**Re: GE-Pittsfield/Housatonic River Site
Newell Street Area II (GECD450)
Response to EPA's April 21, 2003 Conditional Approval Letter for the Pre-Design
Investigation Report**

**RESPONSE TO EPA'S APRIL 2003 CONDITIONAL APPROVAL LETTER FOR THE NEWELL STREET AREA II PRE-DESIGN INVESTIGATION REPORT
GENERAL ELECTRIC COMPANY - PITTSFIELD, MASSACHUSETTS**

FIGURE
4

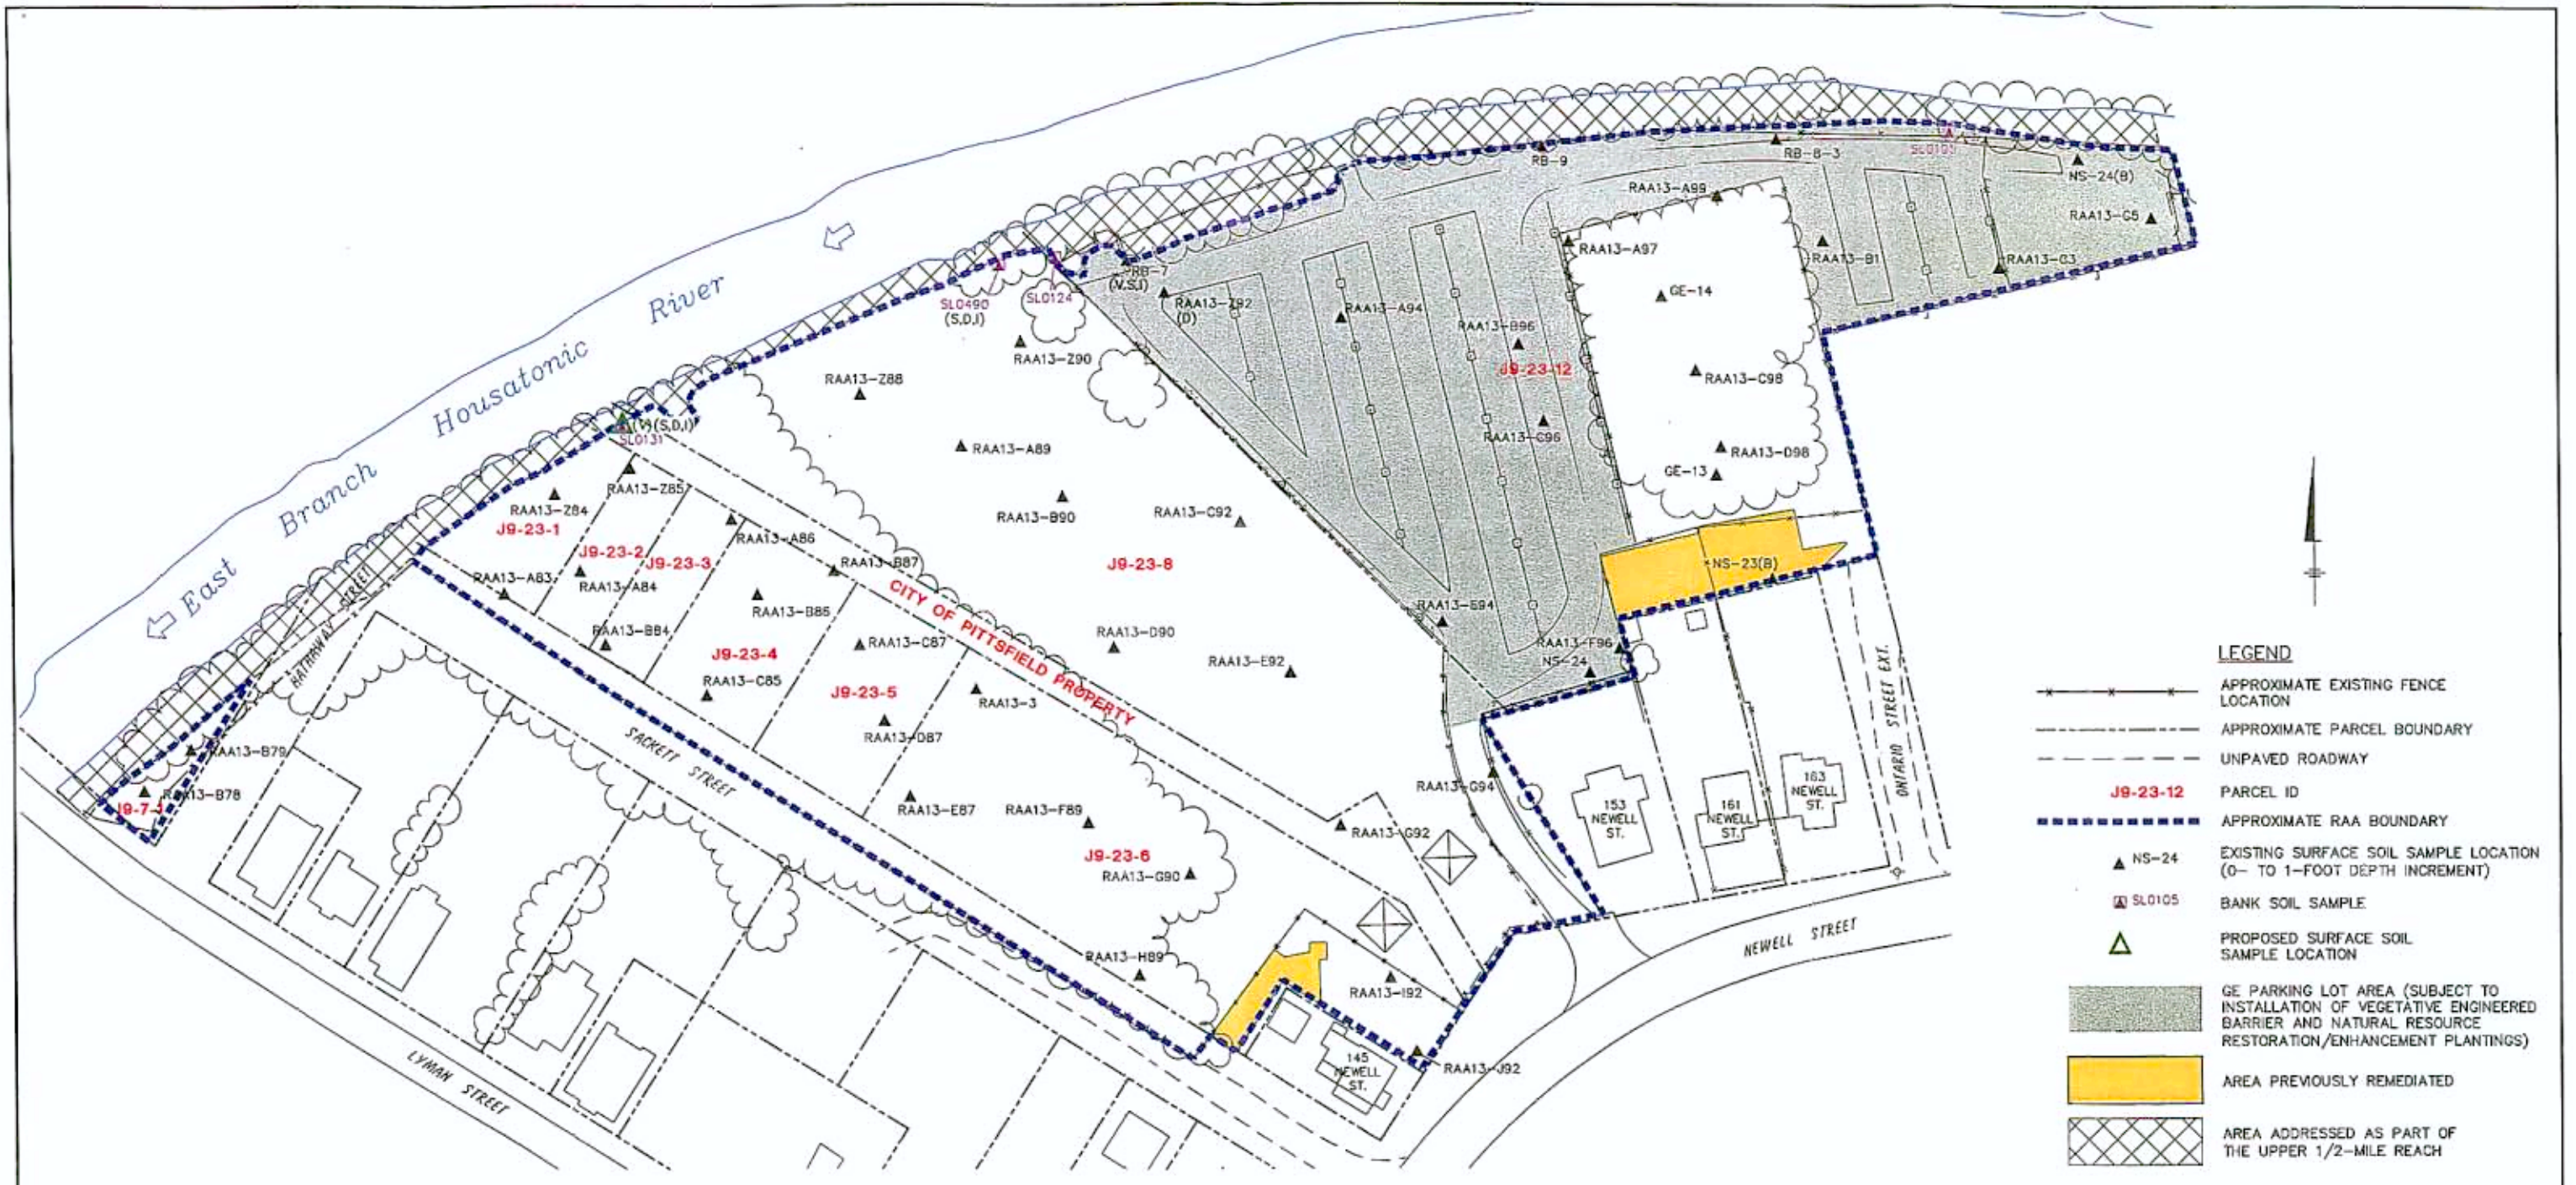
- b. A soil sample will be collected from the 3- to 6-foot depth increment at location RAA13-Z88 and analyzed for SVOCs, inorganics, and PCDDs/PCDFs.
 - c. Soil samples will be collected from the 1- to 3-foot and 3- to 6-foot depth increments at location RAA13-F91 and analyzed for Appendix IX+3 constituents.

Table 1, attached to this letter, reflects the revised scope of supplemental pre-design sampling, showing the supplemental sampling locations, depths, and analyses identified in the PDI Report with the changes described above. Additionally, revised Figures 4 through 8 illustrate the currently proposed supplemental Appendix IX+3 sampling locations, along with the existing Appendix IX+3 soil sample locations from investigations previously performed either as part of or prior to the pre-design investigations. Except as noted in this letter, the procedures and methodologies described in the PDI Report for the supplemental sampling activities will remain unchanged.

1. In its Condition 3, EPA directed GE to clarify and illustrate the extent of the proposed vegetative engineered barrier in the GE parking lot area. In response, the currently anticipated extent of that barrier is identified on Figures 4 through 8 with gray shading. Following completion of the remaining pre-design soil investigations, as well as the detailed survey described in the PDI Report, GE will, as part of future RD/RA activities, more specifically delineate the area to be subject to the barrier.

FIGURE
6

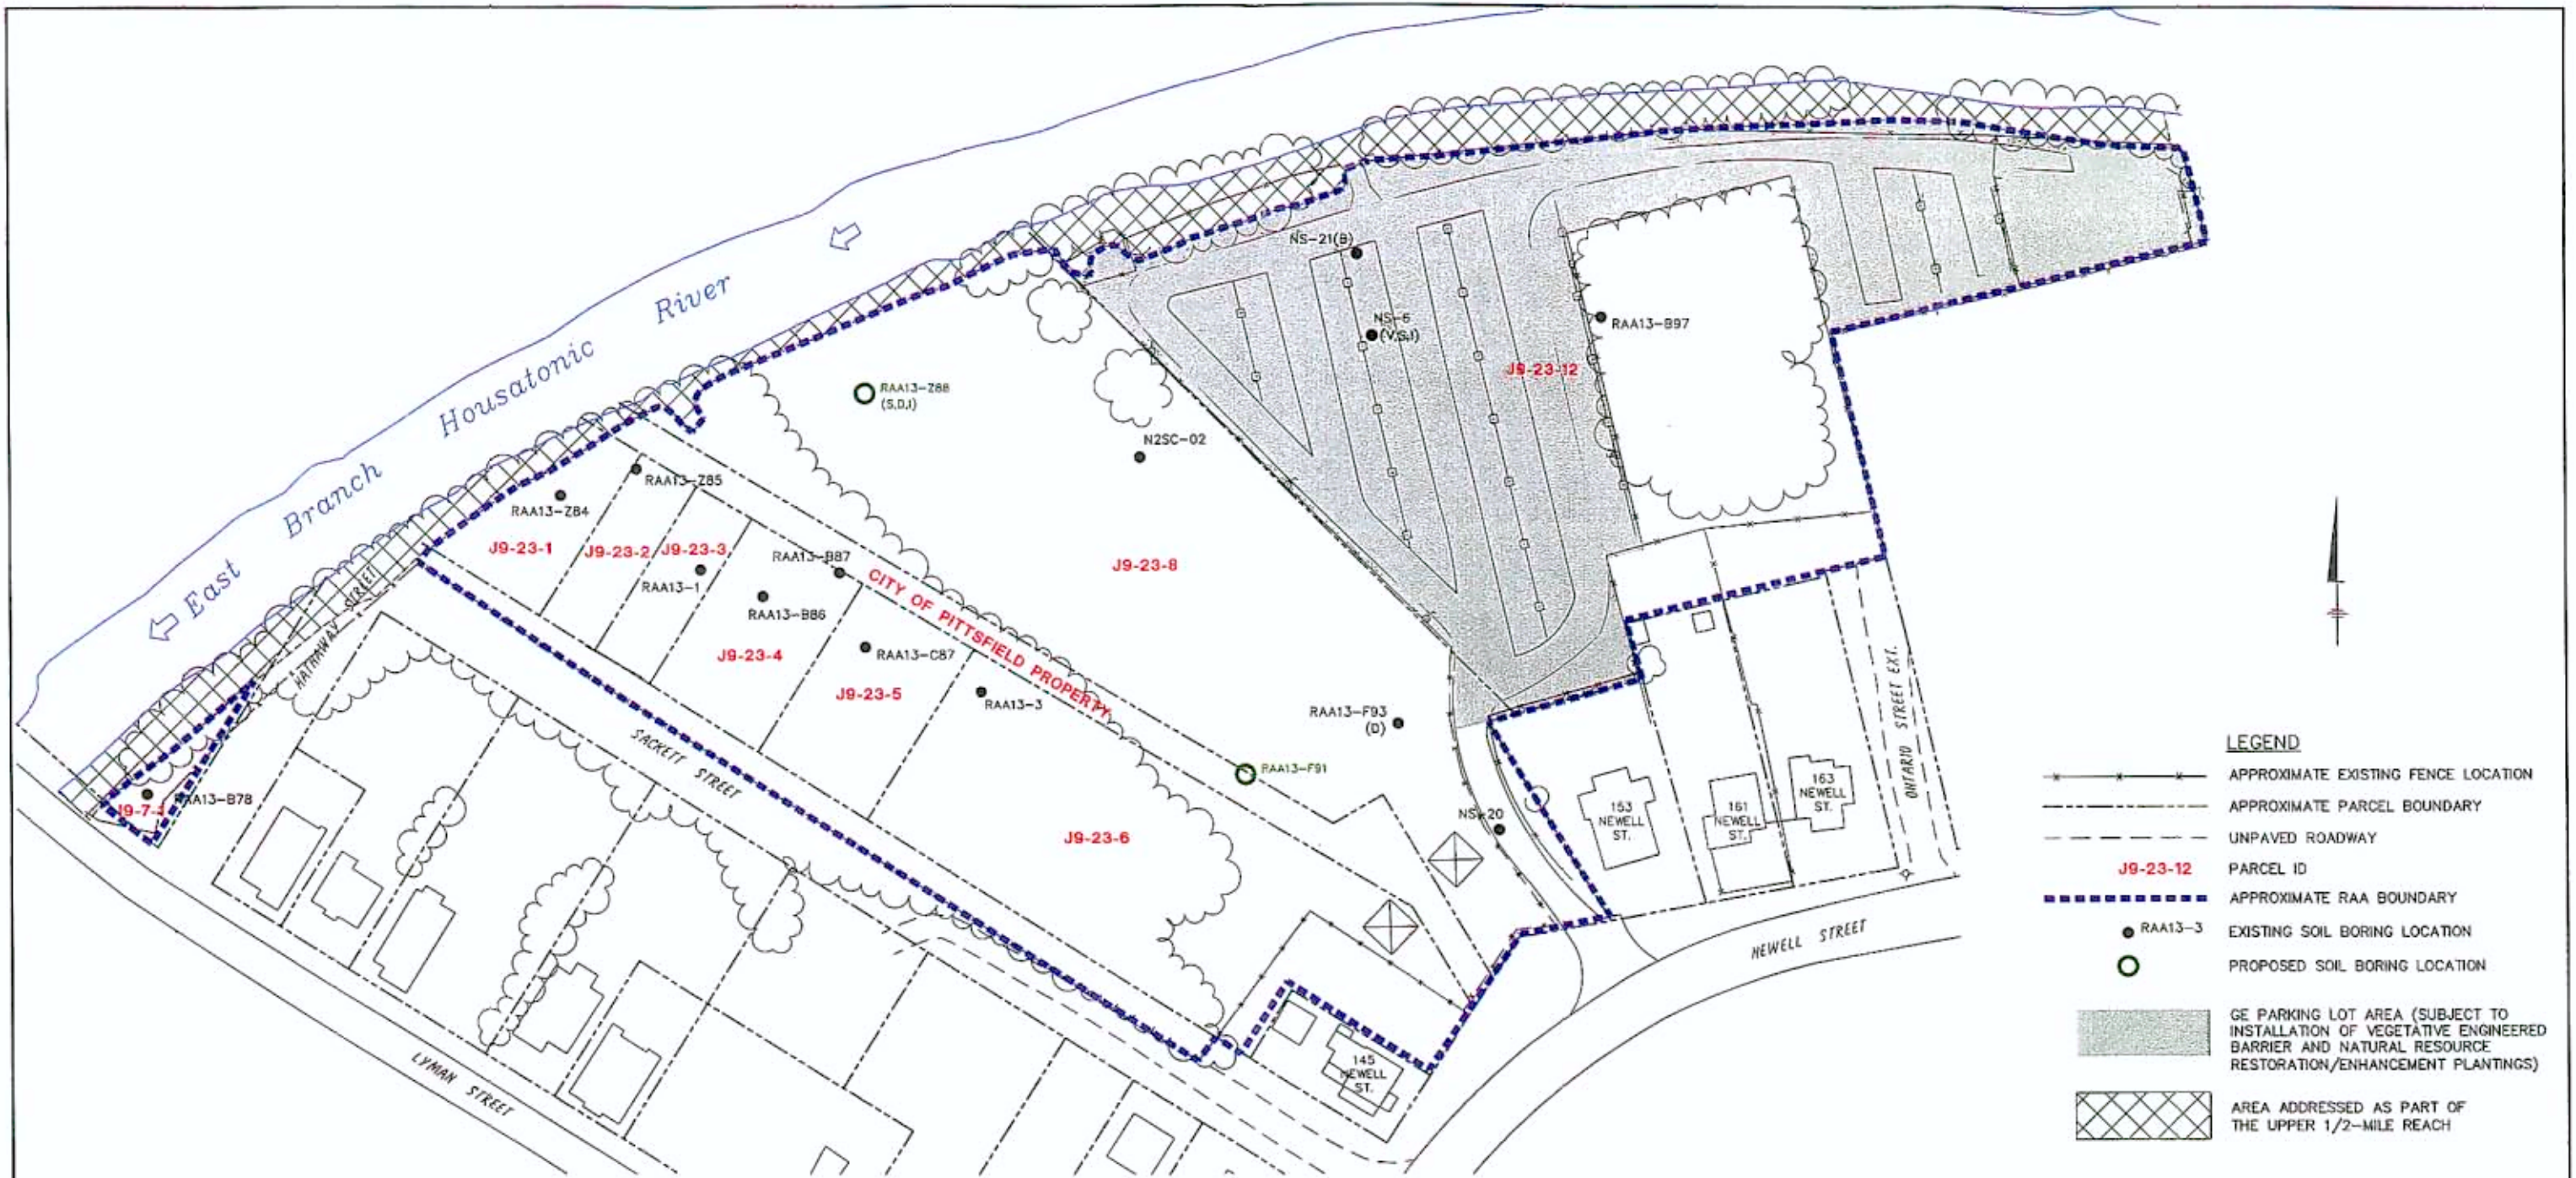
- a. Samples previously proposed for location RAA13-H93 (at the 1- to 3-foot and 10- to 15-foot depth increments) will now be collected from location RAA13-G92. The 1- to 3-foot sample will be analyzed for all Appendix IX+3 constituents (excluding pesticides and herbicides), and the 10- to 15-foot sample will be analyzed for volatile organic compounds (VOCs), semi-volatile organic compounds (SVOCs), and inorganics. The latter sample will not be analyzed for polychlorinated dibenzo-p-dioxins (PCDDs) and polychlorinated dibenzofurans (PCDFs) since PCDD/PCDF data at this depth already exist at location RAA13-H93.

FIGURE 7

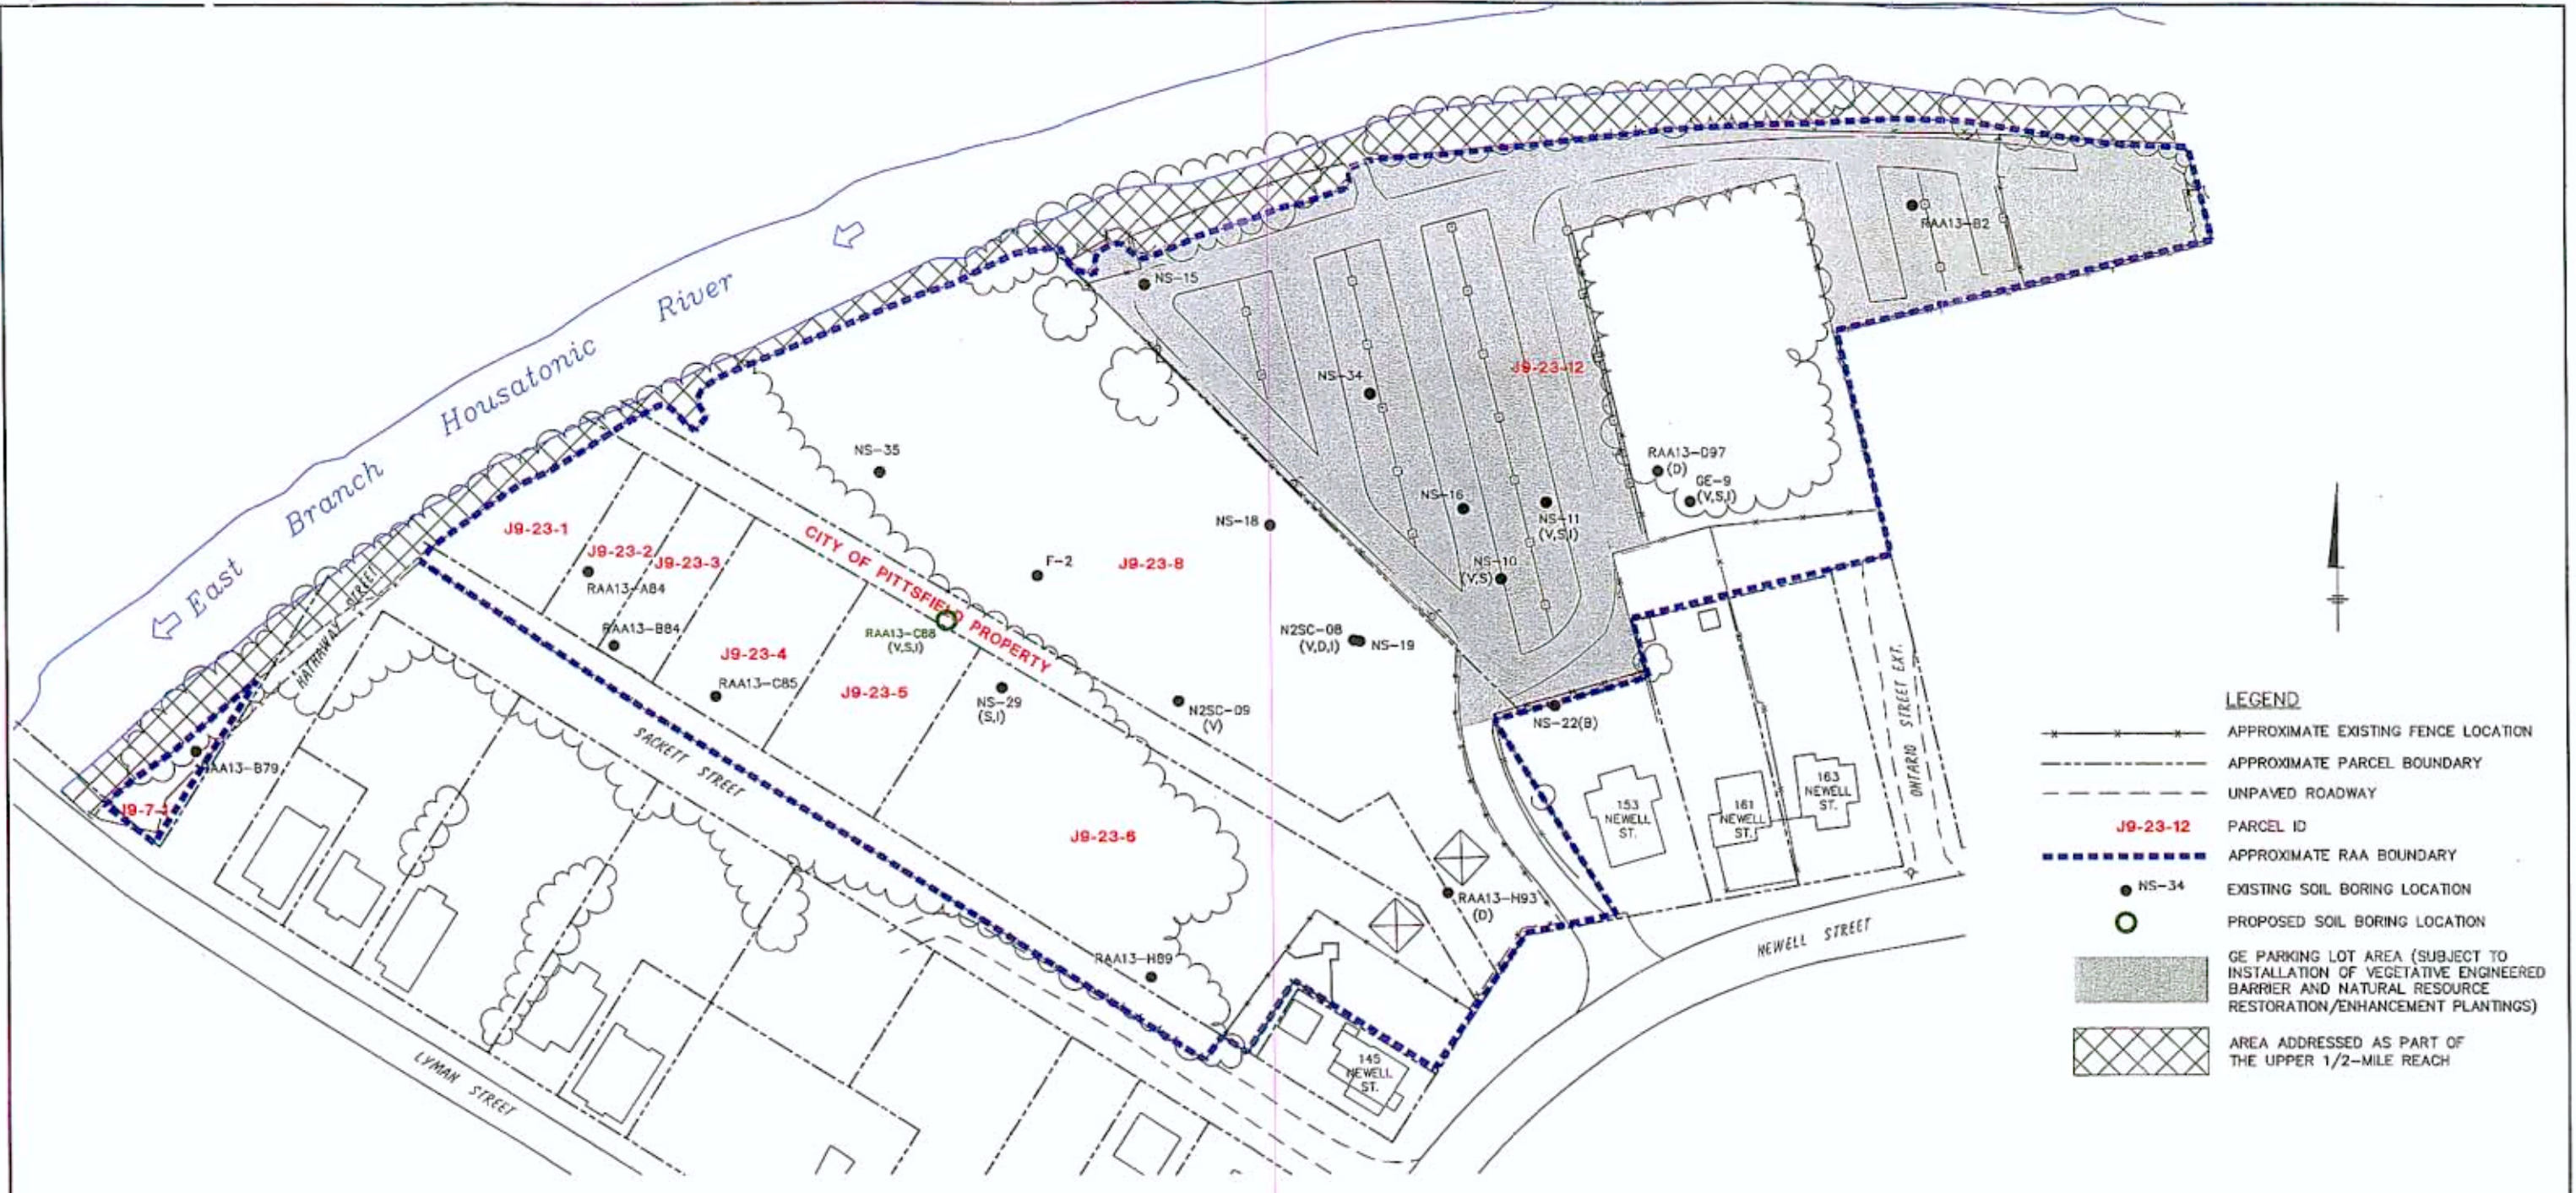
1. In Condition 1 of its April 21 letter, EPA directed GE to ensure that the proposed sampling at locations RAA13-C88 and RAA13-Z90, which is intended to better characterize the PCBs in the soils for utility bands associated with the 20-inch and 48-inch sewer lines, will extend vertically to represent the depth of the bottom of the utility trench bedding material. GE subsequently contacted the City of Pittsfield Engineer who indicated that utility trench bedding can extend two feet below the invert of the utility pipe. To assure adequate coverage for the 20-inch sewer line to include the depth to utility bedding material, GE will extend the boring depth at RAA13-C88 from seven feet to nine feet, and soil samples will be collected from the 1- to 3-foot, 3- to 6-foot and 6- to 9-foot depth increments for analysis of PCBs. For the 48-inch sewer line and for the same reason described above, the soil boring at sample location RAA13-Z90 will be extended to a depth of 15 feet (instead of the originally proposed 12 feet), and soil samples will be collected from the 1- to 3-foot, 3- to 6-foot, 6- to 10-foot, and 10- to 15-foot depth increments for analysis of PCBs.

3. In Condition 5 of its letter, EPA provided comments on some of the tables and figures in the PDI Report and directed GE to make certain changes or clarifications to those tables and figures. GE will make those changes, as appropriate, in the tables and figures to be included in the forthcoming Supplemental Pre-Design Investigation Report (Supplemental PDI Report) described below. In addition, in response to EPA's Comment 5.c, GE notes that all recreational parcels identified on Figure 2 of the PDI Report as "GE owned or in the process of purchasing" are now owned by GE. Finally, the changes that EPA requested to Figures 7 and 8 are also reflected on the revised figures attached to this letter.
